Service information

Reference no.: SDA_109326

Main Switch sparking during switching in Minuto.

Image1

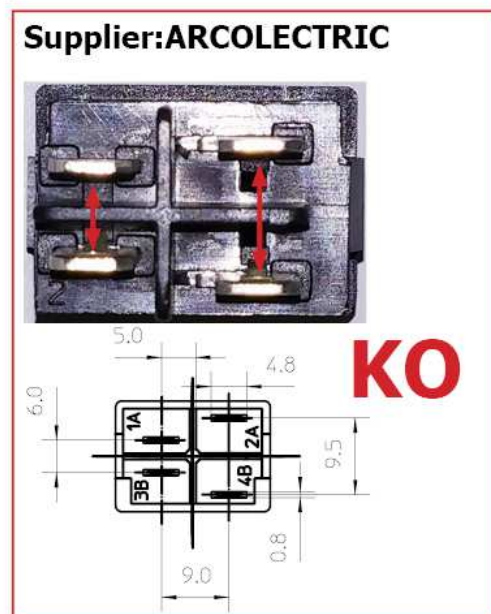
The defect is caused by a bad component supplied by Arcoelectric supplier.

Repair the appliance by using the SWITCH GENERAL BIPOLAR 1 / 0 cod. 242212625104 Supplied from a different supplier than the ARCOLECTRIC o (Image1)

Any stock of the SWITCH GENERAL BIPOLAR I / 0 Supplier ARCOLECTRIC must be scrapped.

Image2

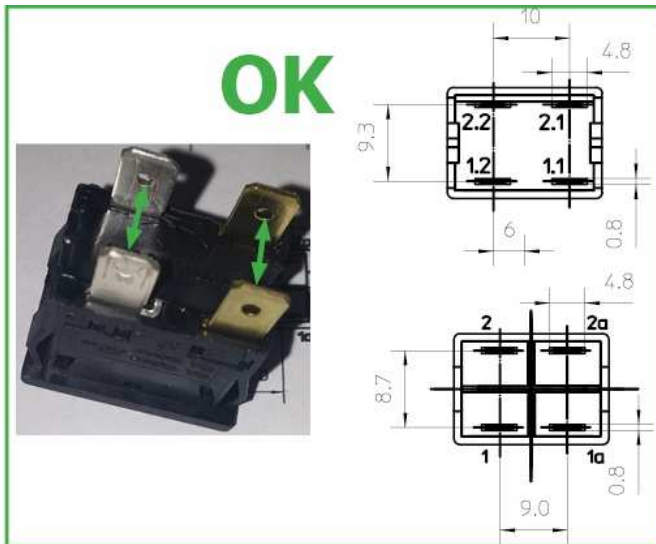
SWITCH GENERAL BIPOLAR 1 / 0 cod. 242212625104 (same code) supplied by other suppliers than ARCOLECTRIC can be identified because they have the same faston interaxes (with or without the plastic cross between contacts). (Image2)

The SWITCH GENERAL BIPOLAR I / 0 of ARCOLECTRIC Supplier on your hand have to be mandatory scrapped.
